Appendix KK
Final SEIR

Renewal of NPDES CA0109223
Carlsbad Desalination Project

**Supplement to the
Precise Development Plan and Desalination Plant Project
Final Environmental Impact Report (EIR 03-05)
City of Carlsbad, California
SCH# 2004041081 and 2015091060
EIR Certified June 13, 2006**

AUGUST 2016

FIGURE 7

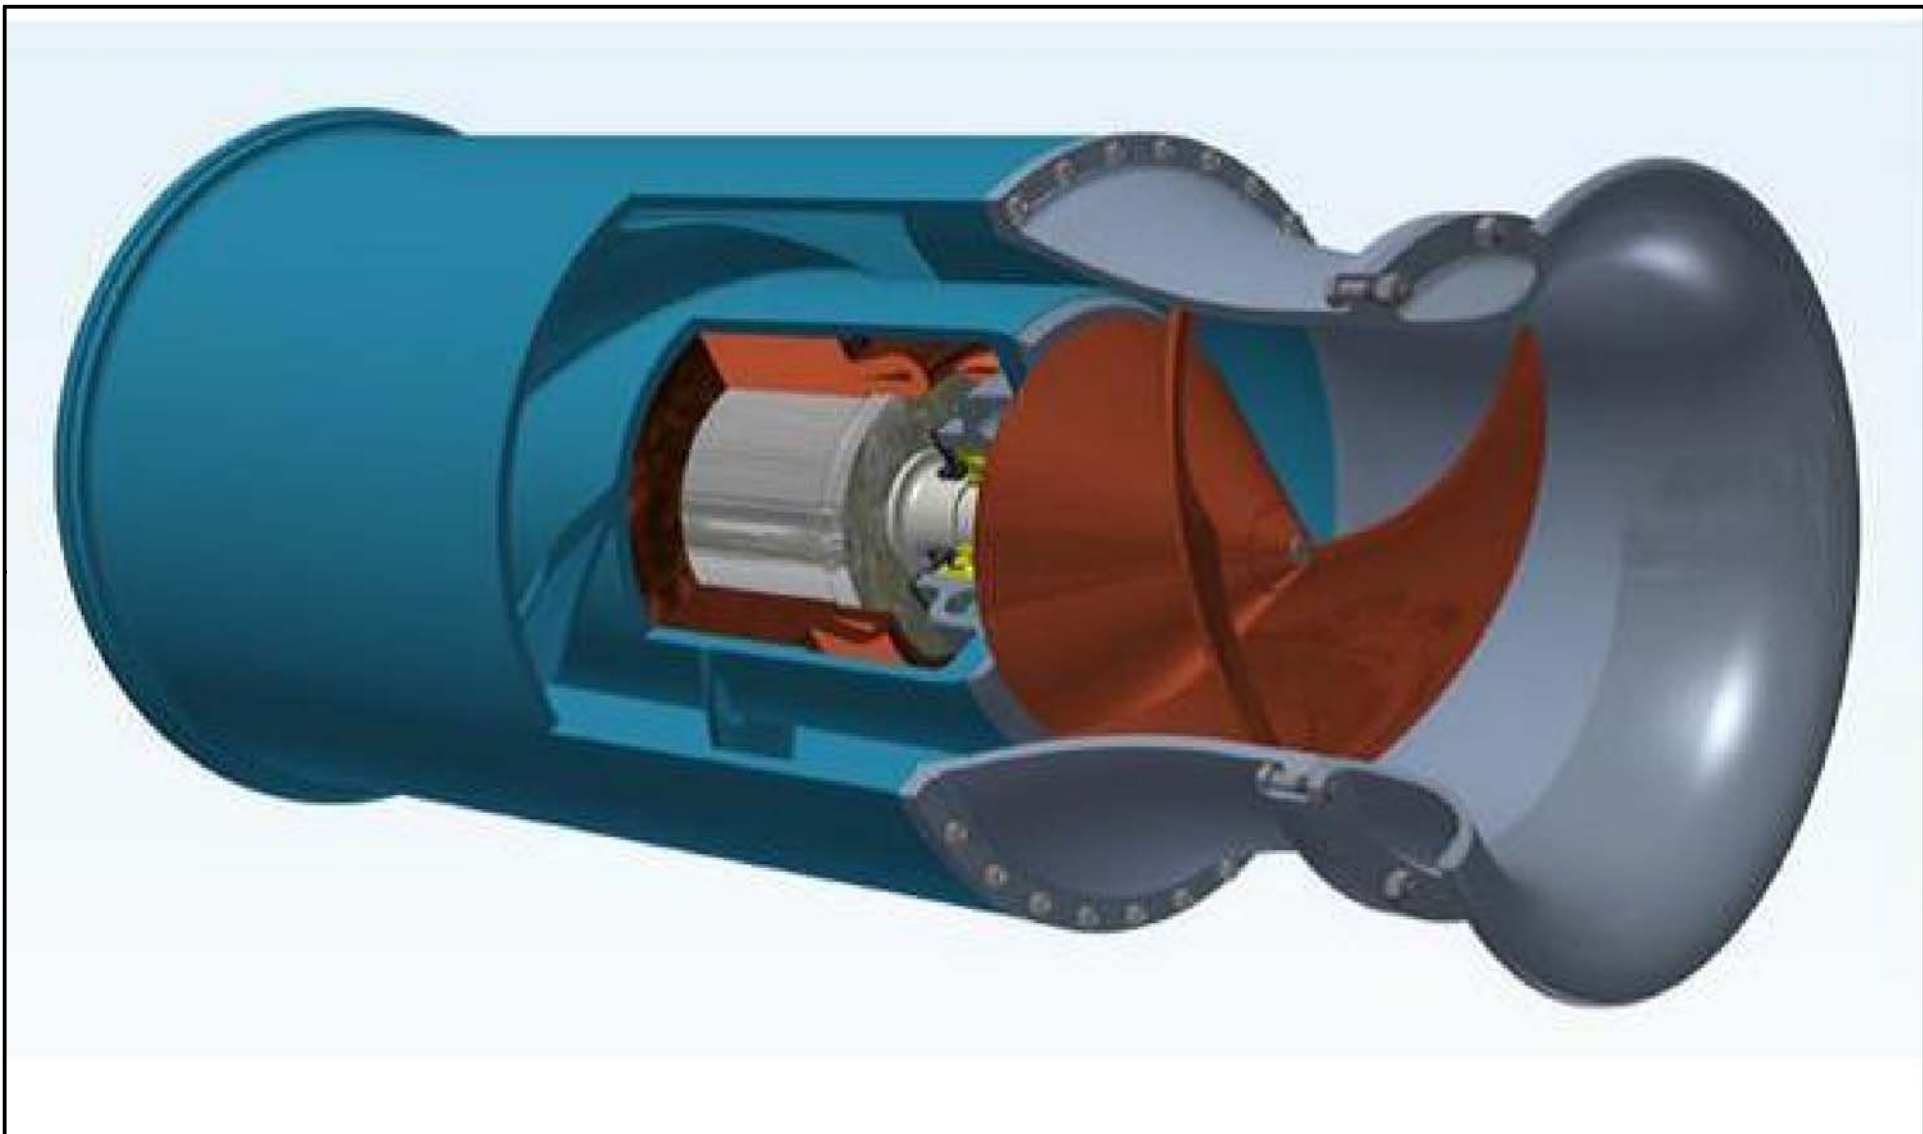
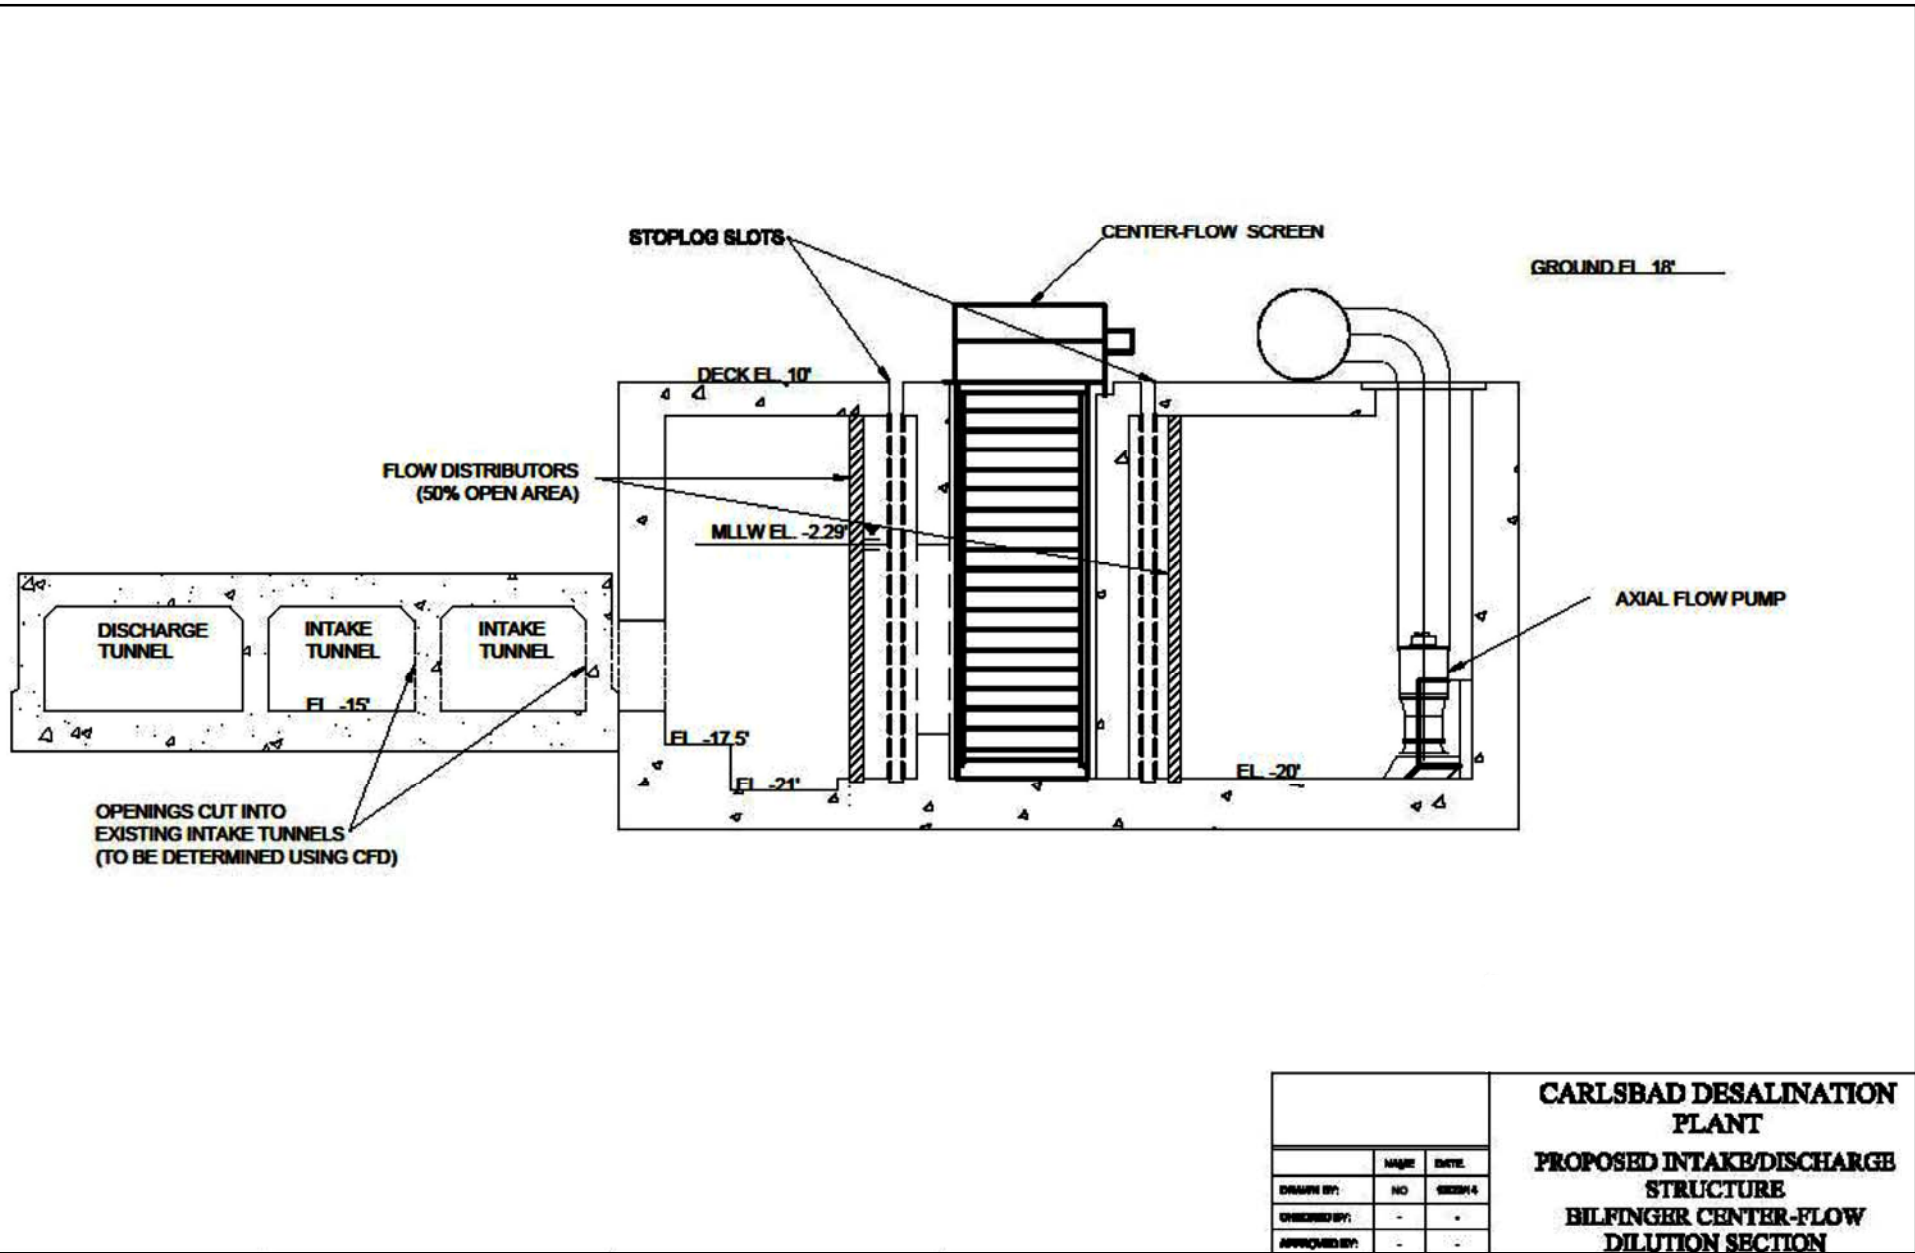
6. In section 4.2, page 4.2-5, there is a description of the proposed CDP modifications to the EPS intake structure, which consist of center-flow traveling water screens with 1 mm mesh, axial flow pumps, and a fish return system. Entrapment of marine life may occur in the intake tunnel, if organisms pass through the trash racks at the onset of the tunnel but cannot swim back through them. The Draft SEIR should be amended to evaluate alternative options, such as wedgewire screens, installation of traveling screens at the onset of intake, and an offshore intake structure, that were considered for modifications to the EPS intake structure and that may result in fewer impacts on marine life.
